Agenda for 83rd PCCM

83rd Protection Coordination Sub-Committee Meeting

Date: 18/09/2025 (Thursday)

C.6 (Agenda B11, 81st PCC) Grid Disturbance in Dharmanagar area of Tripura Power System and Dullavchera area of Assam Power System on 10th June'25:

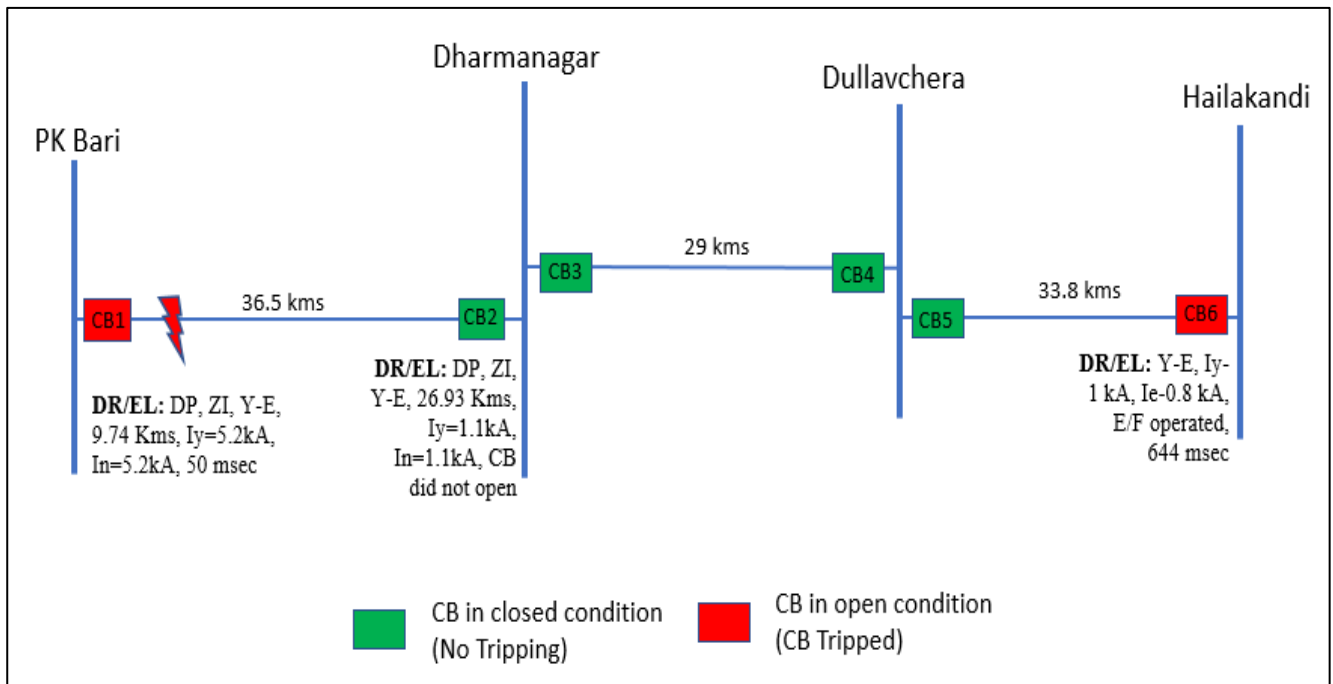
- Non-opening of CB at Dharmanagar end despite issuance of ZI trip command. Reason of non-opening of CB at Dharmanagar needs to be thoroughly investigated.
- Dullavchhara CB (CB4) failed to clear the fault resulting in clearing of fault by tripping of 132 kV Hailakandi-Dullavchhara line.
- Time drift of 5 mins (lag) observed at PK Bari end & 20 mins (lag) observed at Dharmanagar end for 132 kV PK Bari-Dharmanagar Line. Time drift of 4 min at Hailakandi end for 132 kV Dullavchhara Line which needs to be rectified.
- “CB status” not present in DR digital channel. DR digital channels need to be standardized as per recommendation in FOLD working group-3.

Tripura informed that a high resistive fault occurred in the 132 kV P K BariDharmangar line and CB2 did not clear the fault as Y Pole of the CB got stuck which will be checked shortly. DCRM testing to be conducted by TSECL. Forum also noted that EF operation at Hailakandi is aggressive and the settings have to be coordinated with EF of Dharamanagar and Dullavchera substations. E/F setting at Hailakandi end for 132 kV Dullavchera line needs to be reviewed & coordinated with ZIII time delay. TMS to be changed.

In 82nd PCCM, AEGCL informed the forum that no relay coordination issue observed at Hailakandi.

Meghalaya may update**C.8 (Agenda B14, 81st PCC) Grid Disturbance in Margherita area of Assam Power System:****Event 1:**

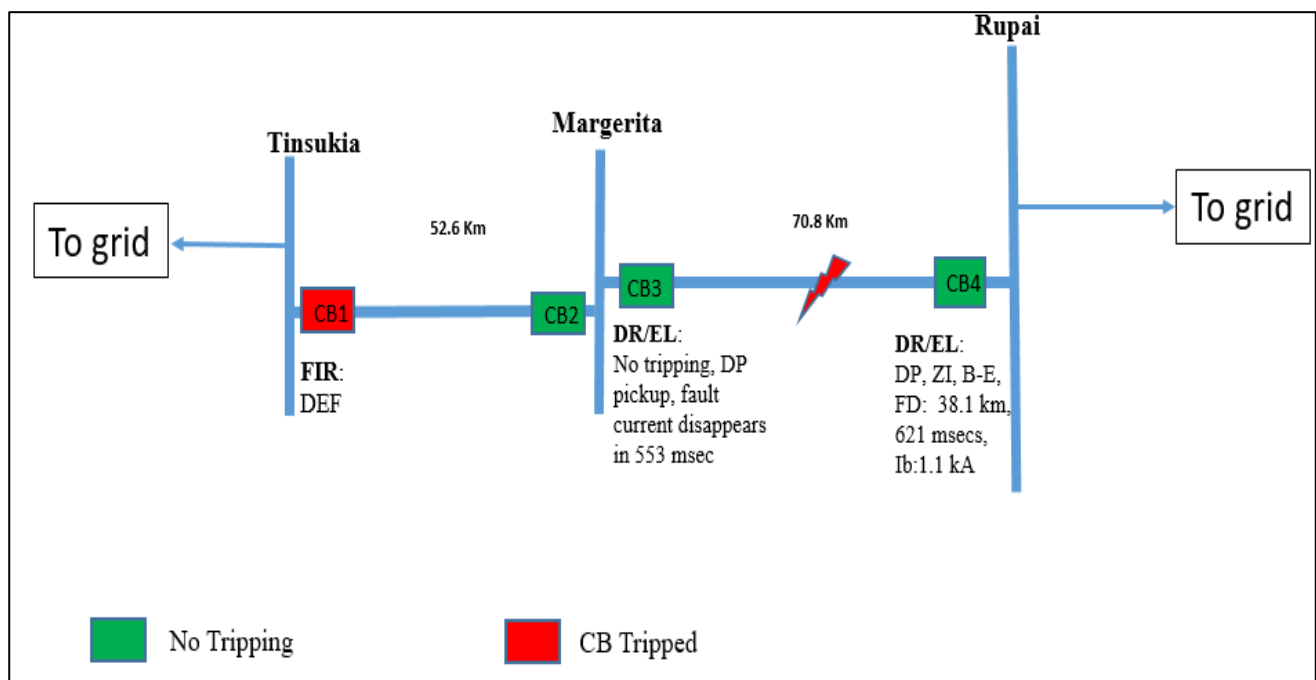
- Protection system at Margherita end for 132 kV Rupai Line failed to isolate the fault leading to clearing of fault by tripping of healthy 132 kV Margherita-Tinsukia line from remote end.
- Time drift of 3 min observed at Rupai end for 132 kV Margherita Line.

Event 1: Forum noted that tripping at Tinsukia on DEF is a maloperation and asked AEGCL to rectify the issue. Further, the forum requested AEGCL coordinate the EF and OC protection settings between Margarita and Tinsukia.

Event 2:

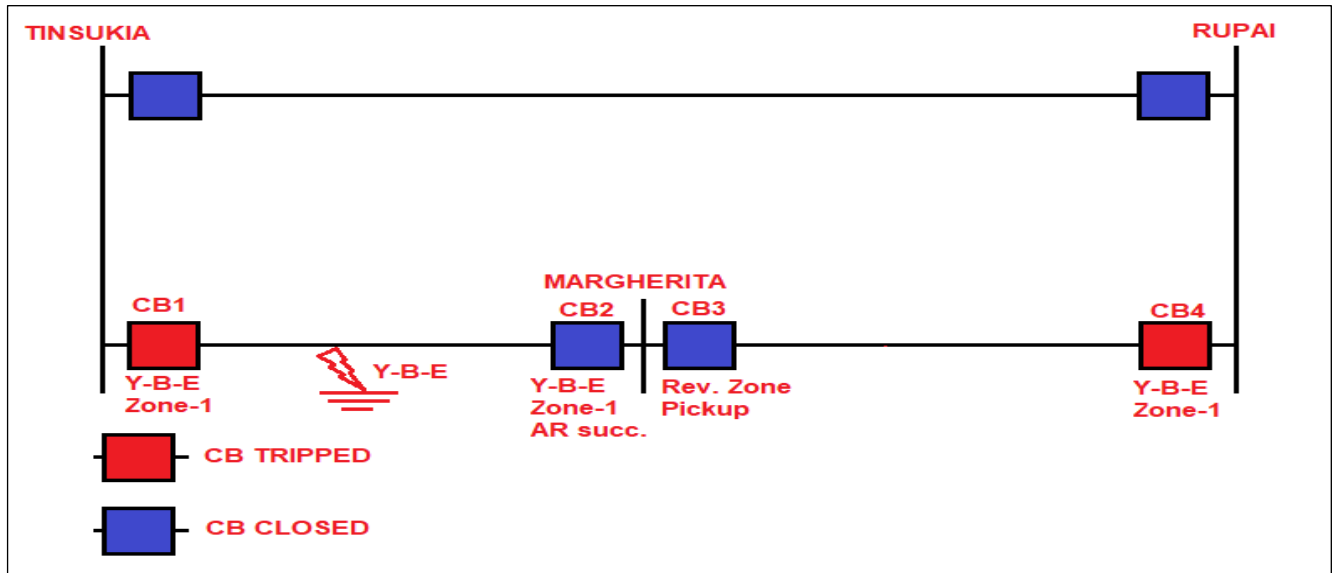
- Tripping of 132 kV Rupai-Margherita Line on ZI from Rupai end is unwanted. ZI setting at Rupai needs to be reviewed.
- Non-operation of Autorecloser at Tinsukia end for 132 kV Margherita line.
- Time drift of 4 min observed at Margherita end for both the lines.

Event 2: Forum noted that zone 1 at Rupai for 132 kV Margherita line is overreaching and requested AEGCL to revise the reach of Zone1 protection. AEGCL informed S/D will be taken for testing of relay.

C.9 (Agenda B15, 81st PCC) Grid Disturbance in Leshka, Mynkre, Mustem and IIM areas of Meghalaya Power System on 19th June'25:

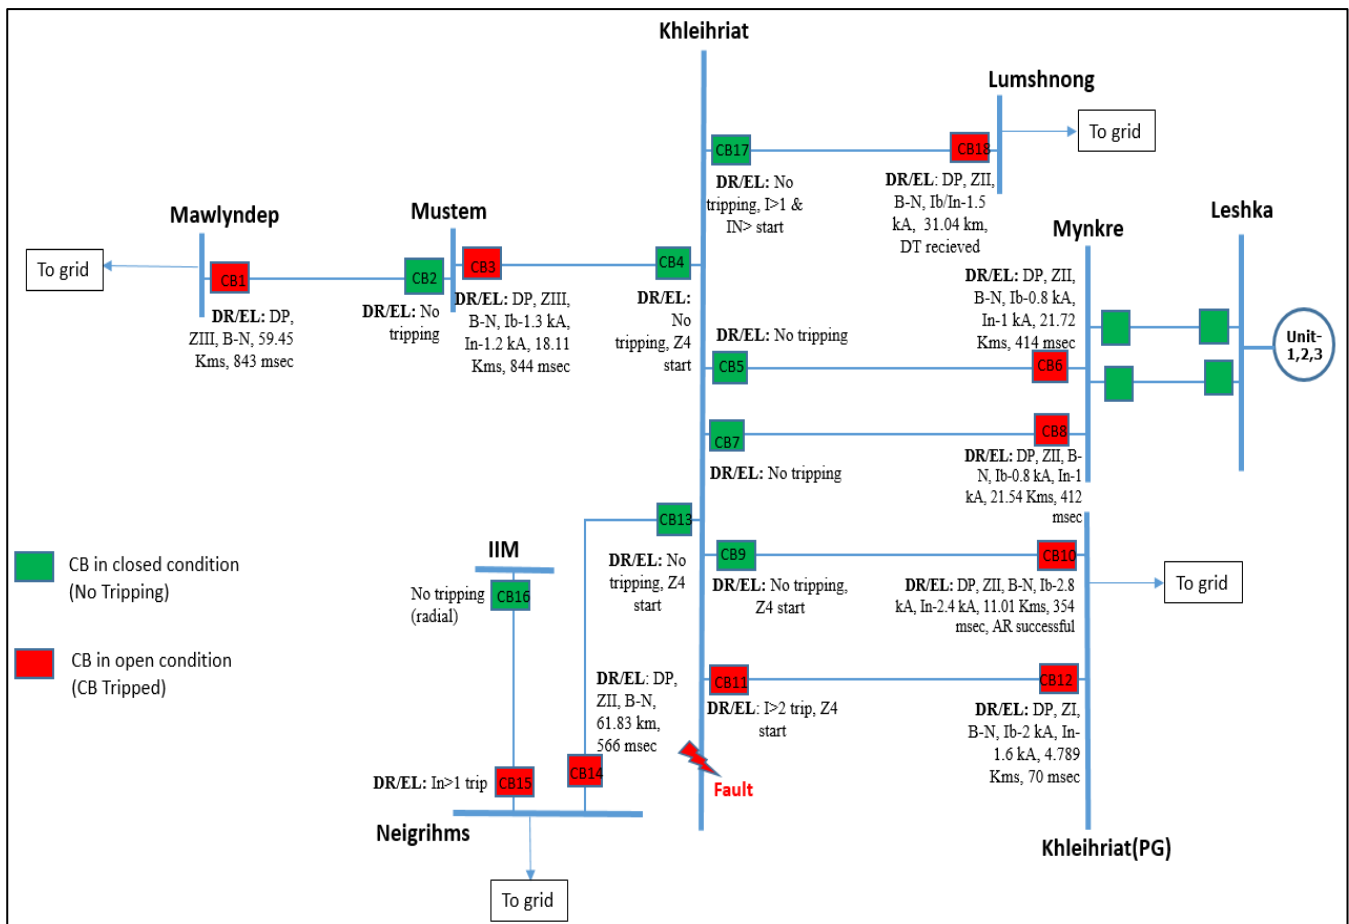
- 132 kV Khleihriat-Khleihriat(PG) II line tripped on ZI from Khl(PG) end. ZI protection seems to have overreached from Khl(PG) end as fault was in Khleihriat Bus. From Khl(ME) end, I>2 trip observed which is inferred unwanted. Highset O/C setting needs to be disabled at Khl(ME) end to avoid any further reoccurrences.

- 132 kV Khleihriat-Khleihriat(PG) I line tripped from Khl(PG) end on operation of DP, ZII. After 3 sec, AR operated successfully which is undesirable. The same needs to be checked by NERTS.

- Tripping of 132 kV Mustem-Khleihriat line on Z3 from Mustem end is inferred unwanted. Z3 reach setting needs to be reviewed and revised as per NER protection philosophy.

- 132 kV Khleihriat-Lumshnong line tripped on ZII from Lumshnong end and no tripping from Khleihriat end (IN>1 start). However, DT received at 13:58:17.814 Hrs which is inferred unwanted. Also, at Lumshnong end, “CB status” showing CB closed which needs to be checked.

- Tripping of 132 kV Neigrihms-IIM line on E/F from Neigrihms end for fault in reverse direction is unwanted. Directionality of E/F relay needs to be enabled and forward direction to be ensured.

- Tripping of Umiam Stg-II Unit-2 for fault in 132 kV Khleihriat Bus is unwanted. The same needs to be thoroughly investigated.
- As 132 kV Khleihriat S/S serves as a crucial S/S in Meghalaya power system, it is advisable to consider upgrading the existing single bus scheme to a Double Main Cum Transfer scheme. This enhancement is essential for ensuring reliability and preventing outage in the event of a bus fault.

- Commissioning of bus bar protection in 132 kV Khleihriat S/S needs to be looked into by MePTCL. Z4 time delay at Khliehriat to be kept at 200 msec till bus bar protection is implemented.
- Time drift of 9 min observed at Mynkre end for Khleihriat line -1&2 lines which needs to be rectified.

1. MePTCL informed that the Bus fault occurred at Khliehriat (ME) due to accidental contact of cables near the bus.
2. Protection Issues:
